Product Change Notification: E-20-007880

Dip Switch Solder legs 3.2mm long

DIP Switch Part Number 5161390

Position Markings are Not Centered

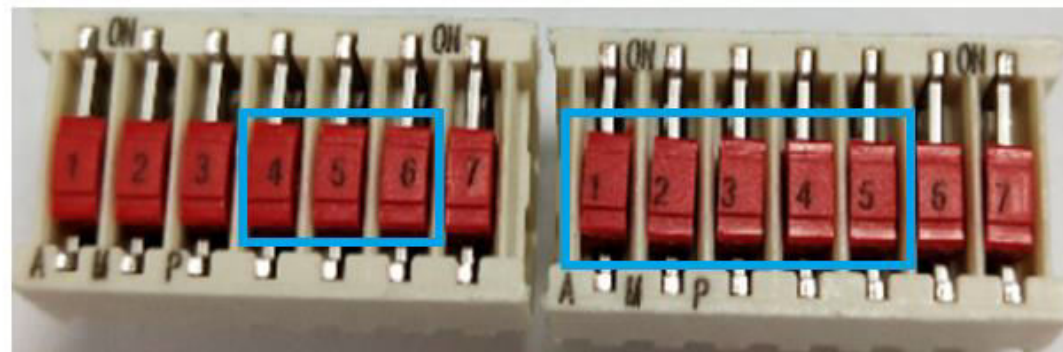
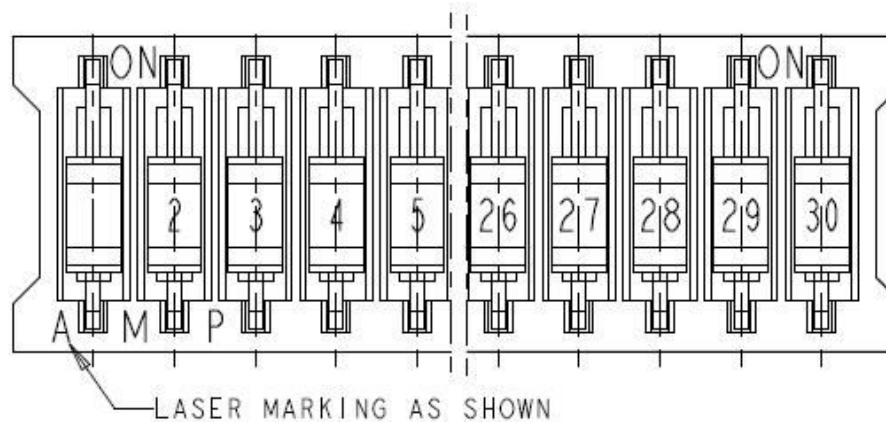
The laser equipment cannot center the numerical position markings. This aesthetic issue has no impact on the performance of the switch. All markings are complete and visible.

- The position of the laser markings is a purely aesthetic issue and has no impact on the performance or reliability of the Switch.
 - Action (TE): TE will revise our specification to add “Position Markings Located as Shown”

Non-compliant Dimensions

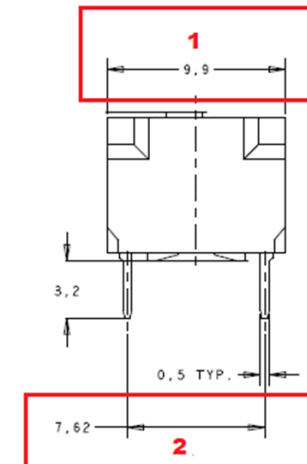
| DIMENSION FIND NUMBER | DIMENSION | | | Actual value | | | | | Comments |
|-----------------------|--------------|-------|-------|--------------|-------|-------|-------|-------|--|
| 1 | 9.9 +0.1/-0 | 9.9 | 10 | 10.05 | 10.05 | 10.02 | 10.06 | 10.04 | The dimension is slightly out of specification by 0.6% maximum, although it might impact board space it is TE's opinion that this dimension is not critical. |
| 2 | 7.62 +/- 0.1 | 7.520 | 7.720 | 7.745 | 7.65 | 7.691 | 7.813 | 7.696 | This dimension is slightly out of specification and can affect the fit of the switch in the PCB. |

- The width of the Switch product exceeds the specified dimension by 0.06 mm. This is only a minor increase in size which should not impact your ability to install the product on the printed circuit board.

- The 7.62 mm pitch of the switch terminations exceeds the specified dimension by 0.1mm. This issue impacts the form and fit of the Switch into the specified printed circuit board layout. TE proposes to change this dimension from 7.62 mm \pm 0.1 mm to 7.62 mm \pm 0.2mm.

- Action (Customer): Please confirm that this dimension does not cause any application issues.
 - Action (TE): Revise tolerance for the width of the switch from 9.9mm +0.1, -0 mm to 10.0mm \pm 0.1mm.

- Action (Customer): Please review your existing printed circuit board layout and provide feedback if the proposed tolerance is acceptable.
 - Action (TE): TE to issue a PCN and revise document to reflect agreed tolerances.
